**Wisconsin Electric** POWER COMPANY  
231 W. MICHIGAN, P.O. BOX 2046, MILWAUKEE, WI 53201

April 28, 1983

DOCKET NOS. 50-266 AND 50-301  
APPENDIX R EXEMPTION REQUESTS  
POINT BEACH NUCLEAR PLANT, UNITS 1 AND 2

FIGURE 7-1  
ELEVATION 8'  
UNIT 1

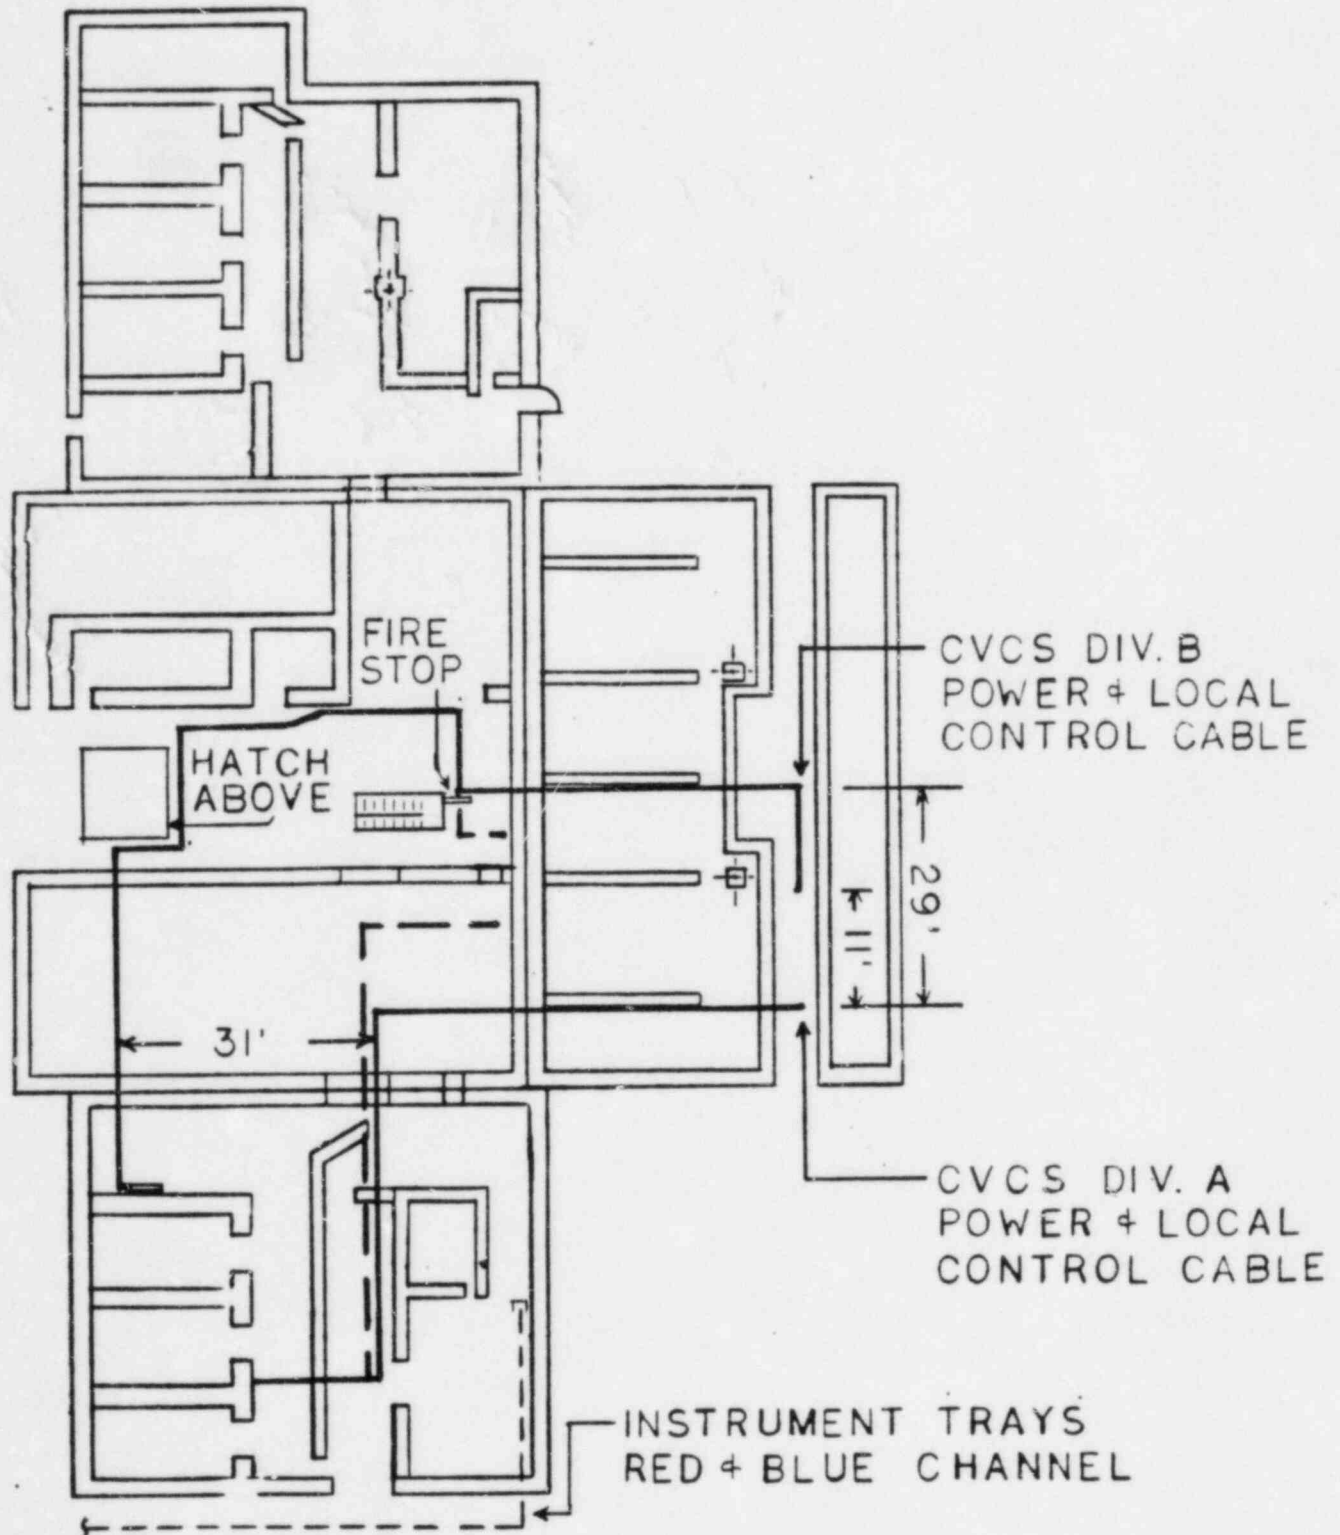
has proposed to relocate division "B" charging pump power and control cable in a manner which will provide greater than 30 feet of horizontal separation between redundant cables as shown on Figure 7-1. The relocated cables will be IEEE-383 qualified cable routed in conduit through the zone. Intervening combustibles consist of three cable trays parallel to and 20 feet remote from the relocated circuit and individual conduits to specific containment spray system components.

Required hot shutdown systems located in the auxiliary building are the CVCS charging system and primary system instrumentation for both units. Two open stairways exist between the 8-foot and 26-foot elevations of the auxiliary building. Figures 7-1 and 7-2 show that the separation of redundant charging pump cables for each unit, which will be provided by the proposed relocation, would exist even if the fire zone division walls were omitted. Figure 7-1 shows that the 29-foot separation of Unit 1 charging pump cables is maintained at a location where both cable divisions are south of the open stairway. Similarly, Figure 7-2 shows that the 27-foot separation of Unit 2 charging pump cables is maintained at a location where both cable divisions are north of the open stairway. Therefore, the presence of the open stairway as a fire propagating pathway will not affect the separation of redundant charging pump cable divisions of either unit. The remote charging pump control cables are routed to the control room in trays which are provided with three-hour fire-rated penetration seals at the 26-foot elevation floor. Therefore, a fire on the 26-foot elevation would not burn back through these trays to affect redundant charging pump cables of either unit.

The routing of primary system instrumentation cables in Fire Zones 1, 3, and 4 is shown on Figures 7-1 and 7-2. These cables are located a minimum distance of 30 feet away from the open stairway.

FIGURE 7-3  
AUXILIARY BUILDING  
ELEVATION 8'

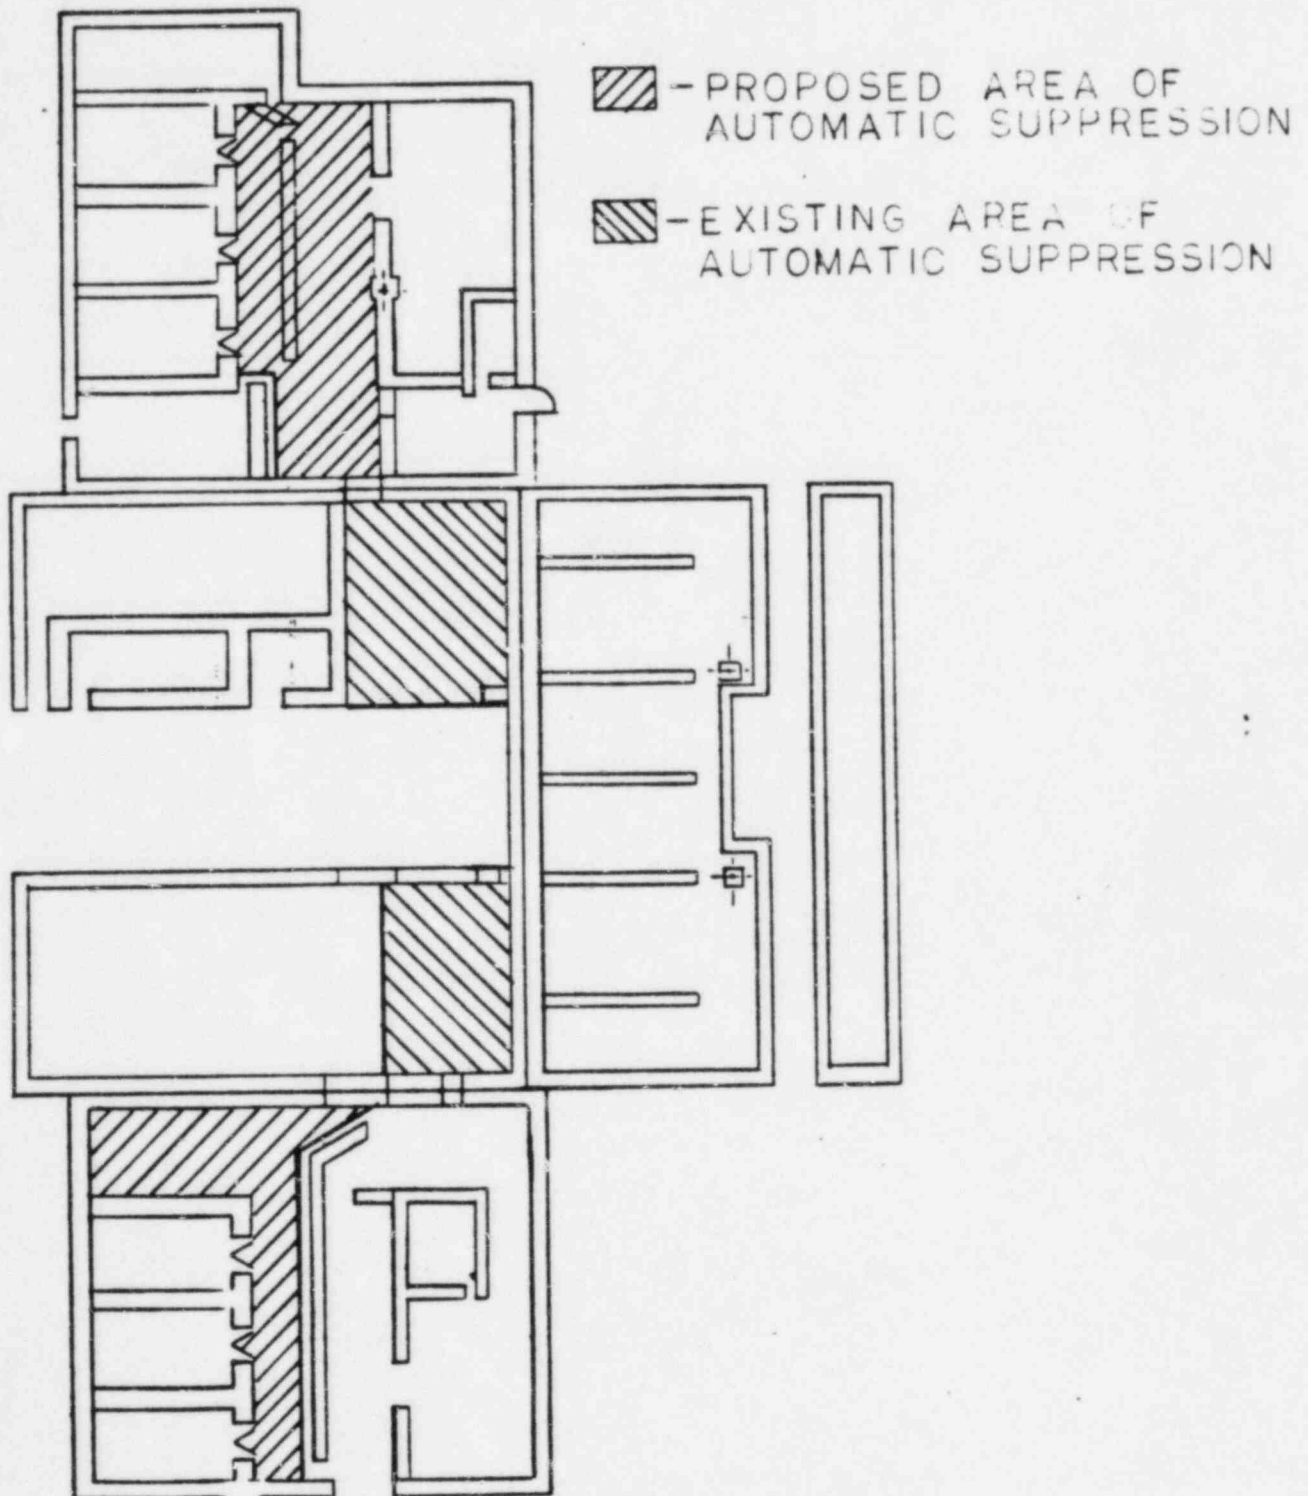
WE has requested exemption from the requirement to provide total zone automatic fire suppression capability because safeguards MCC 1B32 is located within the zone. Following our June 30, 1982 submittal, a partial height radiation shield wall has been constructed in the zone which would protect MCC 1B32 from discharge spray of a partial area automatic suppression system. Therefore, WE has proposed to install a partial zone automatic fire suppression system to provide coverage for one train of redundant cables and the intervening combustibles. The proposed suppression system will include specific doorway coverage to reduce the potential for fire propagation from an individual charging pump room. The area of proposed automatic fire suppression system coverage is shown on Figure 7-3.

WE has requested an exemption from the requirement to provide total zone automatic fire suppression capability because safeguards MCC 2B32 is located within the zone. Following our June 30, 1982 submittal, a partial height radiation shield wall has been constructed in the zone which would protect MCC 2B32 from discharge spray of a partial area automatic suppression system. Therefore, WE has proposed to install a partial zone automatic fire suppression system to provide coverage for one train of redundant cables and the intervening combustibles. The proposed suppression system will include specific doorway coverage to reduce the potential for fire propagation out of an individual charging pump room. The area of automatic fire suppression system coverage is shown on Figure 7-3.

FIGURE 7-6  
AUXILIARY BUILDING  
ELEVATION 46'  
FLOOR LAYOUT

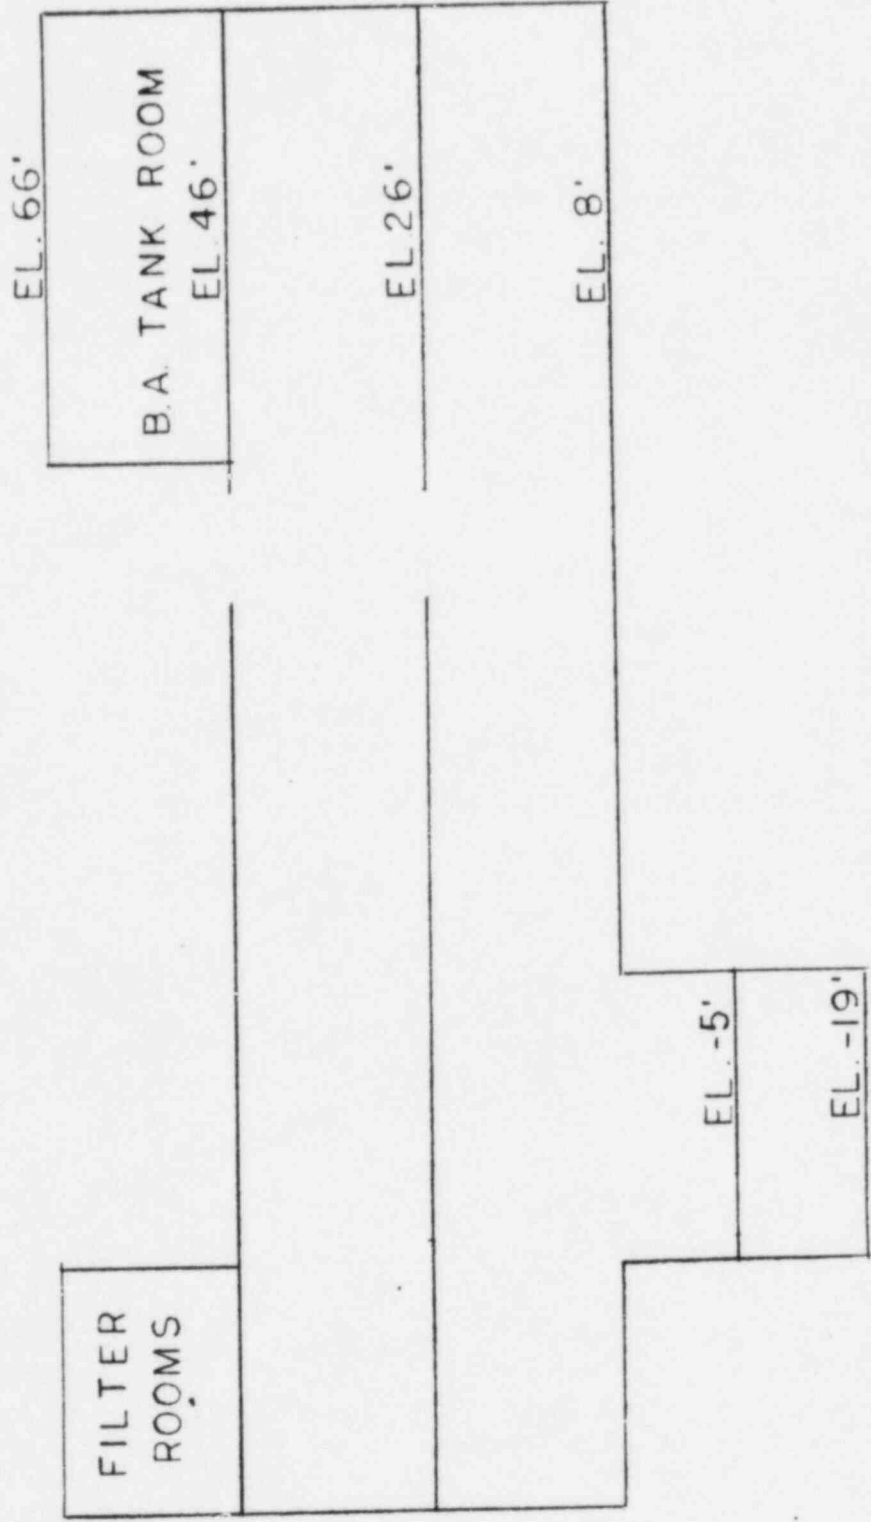
The Point Beach auxiliary building fire area has been established by totally enveloping the areas of seismic construction with three-hour fire-rated barriers except for the central area 46-foot elevation which contains open stairways, an open hatch, and open doorways to the boric acid tank room as shown on Figure 7-6. Therefore, the Point Beach auxiliary building does not satisfy the literal requirements of Appendix R, Section III.G.2.a for a fire area.

The remainder of elevation 46 feet is open floor span. Floor penetrations are provided with three-hour fire-rated penetration seals except for the following openings: several hatches which are normally closed with concrete plugs exist in the open floor area to enable maintenance and removal of filter and ion exchanger equipment located on lower elevations. The plugs are fire resistive but the openings are not sealed in order to accommodate plug removal for necessary maintenance activities. In order to provide suitable access to the equipment for which the hatches have been provided, no combustibles, cable trays, or equipment are located in the intervening space. Therefore, the plugged hatches do not present a fire hazard to hot shutdown required systems.

The elevation 46 foot floor also contains an open stairway and one 13-foot by 15-foot open hatch. The open stairway is continuous to the (-19)-foot elevation. The stairway is located 45 feet west of Unit 2 division "A" charging pump cables at the 8-foot elevation. Therefore, the stairway does not present a fire hazard to hot shutdown systems. The open hatch No. 3 is continuous to the 8-foot elevation in Fire Zone 3. The hatch location relative to CVCS system charging pump cables is shown on Figures 7-1 and 7-2. Both divisions of Unit 1 charging pump cables are located to the east of the hatch opening as shown on Figure 7-1. Therefore, the presence of the hatch does not affect the horizontal separation of Unit 1 redundant cables. The Unit 2 division "A" charging pump cables are routed around the hatch opening as shown on Figure 7-2. However the location of the hatch is separated from division "B" cables by a horizontal distance of 46 feet. This is greater than the 27-foot horizontal separation of redundant cables and the presence of the hatch will not affect the horizontal separation of Unit 2 redundant cables.

The majority of the elevation 46-foot floor penetrations terminate in Fire Zone 7 on the 26-foot elevation. Alternate shutdown capability will be provided for Fire Zone 7 as discussed in Section 7.5. The above discussion demonstrates that the few continuous penetrations to the 8-foot elevation will not affect hot shutdown capability. Therefore, WE requests that the staff grant an exemption from the literal three-hour barrier requirement of Appendix R, Section III.G.2.a, for the elevation 46-foot floor of the Point Beach auxiliary building.
